Access Compliance Report

(Curb Ramps)

Intersection ID: 31463	Main Street: COBDEN_LN	Cross Street: HARLAND_ST	Location: S
ADA ID: B7D0E7F5BBEF	Ramp Type: BlendTrans2	Initial Pass/Fail: Pass	Overall Compliance: No
Severity Score: 0			
Codes/Mitigation Info/Possible Solution		Field Measurements/Component Compliance

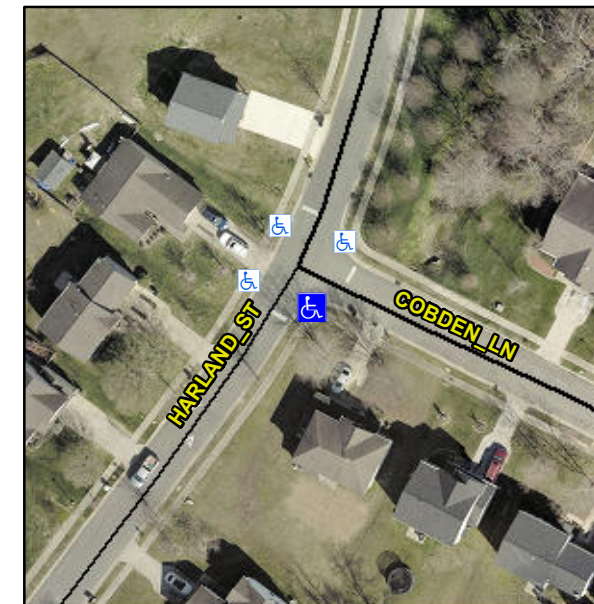
Not Found, R305.2, R304.5.3

Compliance	Description	Data	Compliance	Description	Data
N/A	Ramp Length (in)	97.0	Yes	BlendTrans Slope (%)	3.5
Yes	Ramp Width (in)	48.0	Yes	BlendTrans XSlope (%)	0.8
N/A	Flare Type LT	None	N/A	Flare Type RT	None
N/A	Flare Slope LT (%)	N/A	N/A	Flare Slope RT (%)	N/A
N/A	Flare Traversable LT?	N/A	N/A	Flare Traversable RT?	N/A
N/A	Landing Length (in)	N/A	Yes	DWS Provided?	Yes
N/A	Landing Width (in)	N/A	Yes	DWS Contrast?	Yes
N/A	Landing Slope (%)	N/A	Yes	DWS Length (in)	24.0
N/A	Landing X Slope (%)	N/A	Yes	DWS Full Width?	Yes
N/A	Landing Curb? (Y/N)	No	No	DWS Offset (in)	7.0
N/A	Shared Landing?	No			
Yes	Gutter Ponding?	No	Yes	Gutter Slope (%)	3.2
Yes	Gutter Lip Ht (in)	0.0	No	Gutter X Slope (%)	3.9
N/A	Painted X Walk1?	No	N/A	Painted X Walk2?	No
	X Walk 1 Direction	To NE		X Walk 2 Direction	To NW
	X Walk 1 Width (in)	N/A		X Walk 2 Width (in)	N/A
	X Walk 1 Slope (%)	2.3		X Walk 2 Slope (%)	4.1
	X Walk 1 X Slope (%)	2.3		X Walk 2 X Slope (%)	3.0

N/A	Ramp inside XWalk1?	N/A	N/A	Ramp inside XWalk2?	N/A
	Road Slope (%)	0.9		Clear Space?	Yes
	Road X Slope (%)	4.2	N/A	Clear Space to XWalk (in)	N/A
Yes	Any Obstructions?	No	Yes	Storm Grate/Utility Hazard?	No
	Obstruction Type			Storm Grate/Utility Type	
		N/A			N/A
			Yes	Surface Condition? (G/P)	Good
			No	Curb Slope (%)	21.4

Remove & Replace Curb Ramp With Two New Directional Ramps or Equivalent. Remove & Replace Gutter.
